PACIFIC GAS AND ELECTRIC COMPANY - DIABLO CANYON UNIT NO. 1
DOCKET NO. 50-275

Report of Inspection

CO Report No. 50-275/70-5

Licensee: Pacific Gas & Electric Company
Diablo Canyon Unit No. 1
Construction Permit No. CPPR-39
Category A

APPENDIX - B

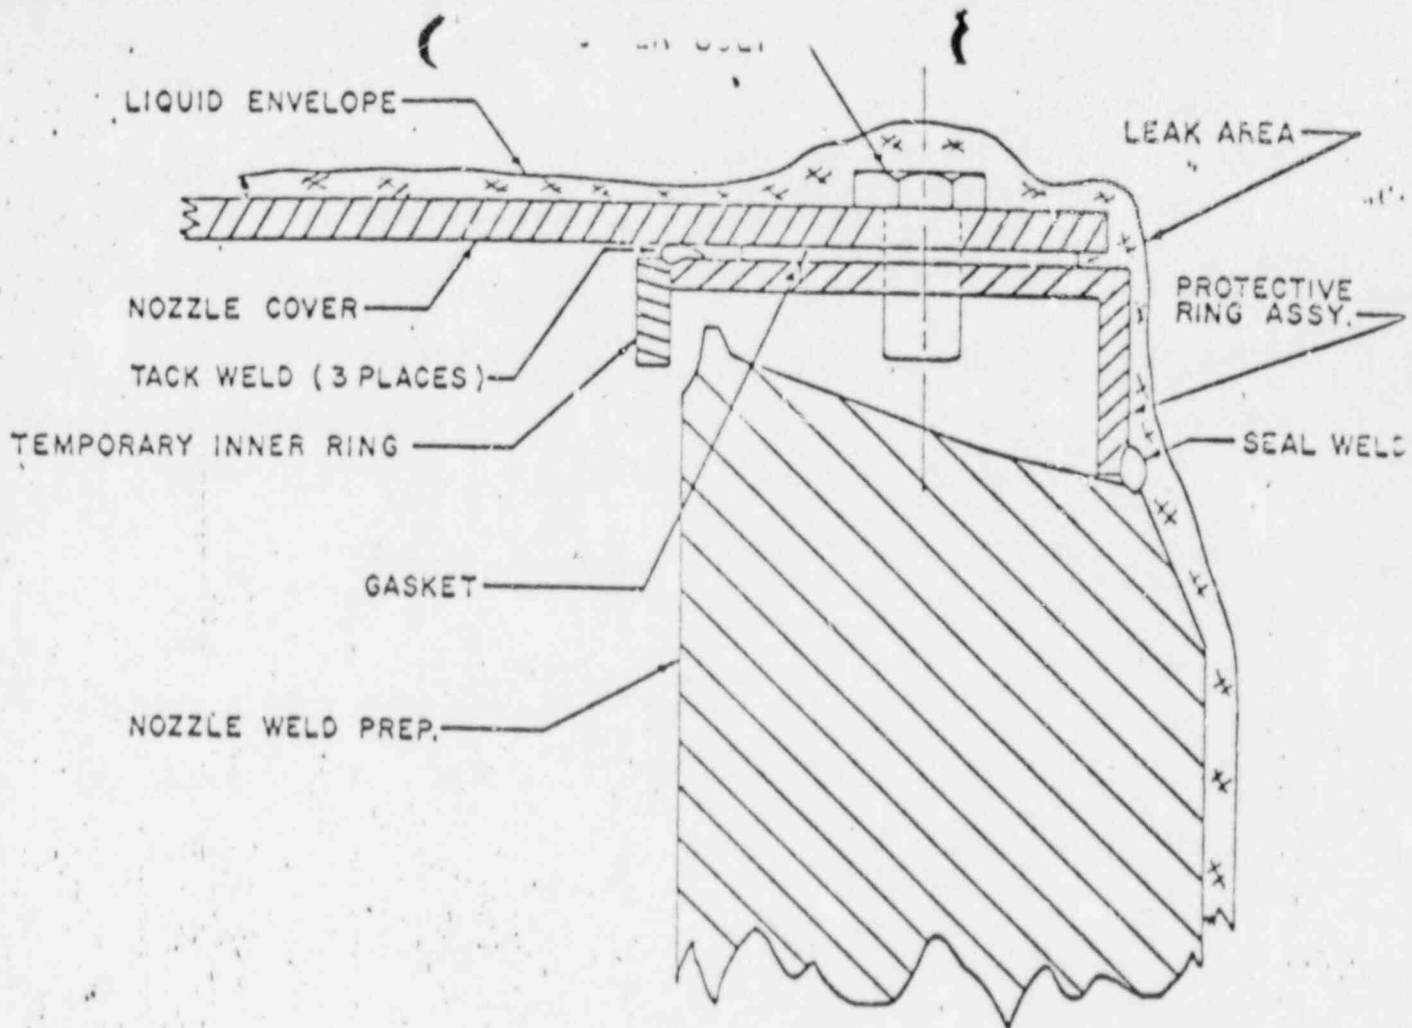
A report of a meeting between Westinghouse and PG&E personnel discussed the design of the shipping closure of the steam generator channel nozzles and why they failed. (Appendix B shows a diagram of the problem area.) The nozzle weld preparations were protected by an angle iron ring seal-welded to the end of the nozzle outside of the weld preparations. Another ring was tack welded to this ring, inside it and the weld preparations, for further

protection during manufacture. When the steam generators were prepared for shipment, the tack welded inner rings were to have been removed and gasketed covers bolted to the seal welded rings. However, the inner rings were not removed, and the covers were prevented from seating as intended, resulting in leakage paths past the tack welded joints. Plastic coatings were sprayed on the outside of the bolted closures, but the coating failed. There was no procedure requiring removal of the temporary rings, although there was a note calling for their removal on a drawing. The procedure has now been revised to call for this step. Westinghouse stated to PG&E that they had such confidence in the closure design that they conducted no tests of the integrity of the shipping preparation.

THE SALT WATER INTRUSION OCCURED BECAUSE:

- 1- THE SHOP FAILED TO REMOVE THE TEMPORARY INNER RING PRIOR TO SHIPMENT OF STEAM GENERATORS.
- 2- THE TACK-WELDS PROJECTED SUFFICIENTLY TO PREVENT THE SHIPPING COVERS FROM SEATING ON THEIR GASKETS.
- 3- THE "LIQUID ENVELOPE" FAILED DURING THE BARGE TRIP ALLOWING SEA WATER TO CONTACT THE METAL SURFACES.

Westinghouse has changed the nozzle closure design from bolted to seal welded. Al Hickman PG&E Resident Mechanical Engineer stated a preference for the original design, if correctly executed, because access for inspection in the field is easier.
